# Microcomputer Technical Information

<p><math>\mu</math>PD789860, 789861 Subseries</p> <p>Usage Restrictions</p>	Document No.	SBG-DT-03-0195-E	1/2
	Date issued	July 18, 2003	
	Issued by	Microcomputer Group 2nd Solutions Division Solutions Operations Unit NEC Electronics Corporation	
Related documents $\mu$ PD789860, 789861 Subseries User's Manual: U14826EJ3V0UM00 $\mu$ PD789860, 789861 Data Sheet: U13917EJ1V1DS00 $\mu$ PD78E9860, 78E9861 Data Sheet: U16524EJ1V0DS00	Notification classification	√	Usage restriction
			Upgrade
		√	Document modification
			Other notification

## 2. Details of modification and added restriction

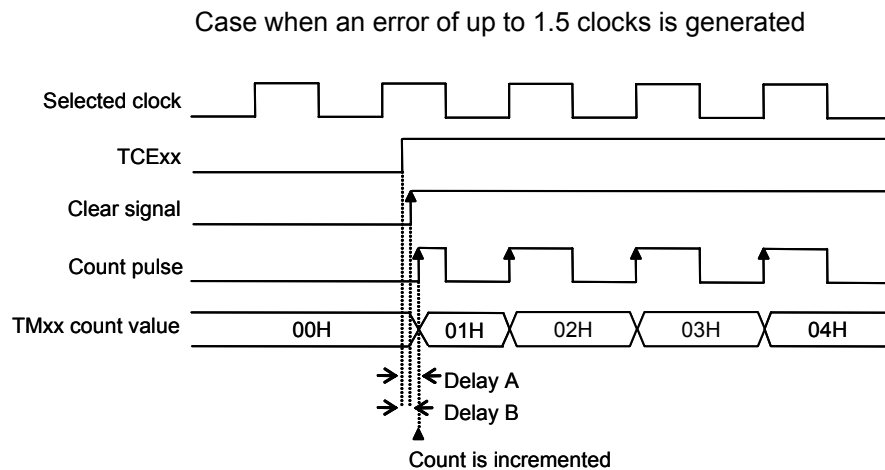
The basic timer configuration applicable to this restriction is shown in the figure below.

- The selected clock and the count operation flag (TCExx) are ANDed, and the result is supplied to the counter
- The TMxx counter value is cleared when the count operation flag (TCExx) is set

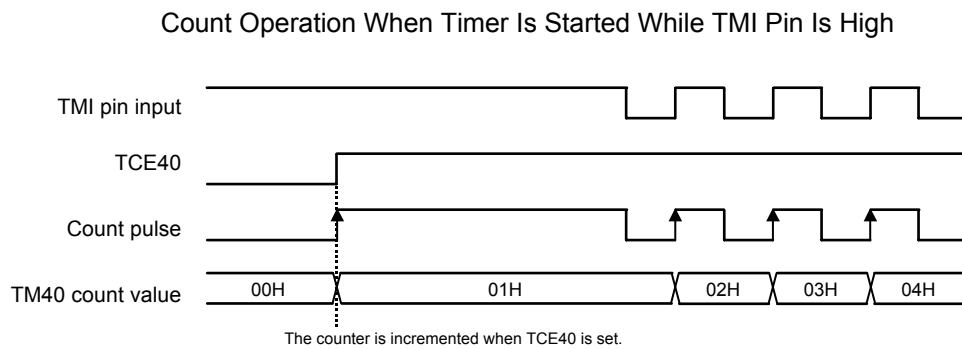
If a count pulse is delayed for the clear signal (“delay A > delay B”) as the result of setting the count operation flag (TCExx) while the selected clock is high, the TMxx count value is incremented. An error of up to 1.5 clocks is generated.

**Remark** See Basic Timer Configuration above for details of the selected clock, TCE, clear signal, and count pulse.
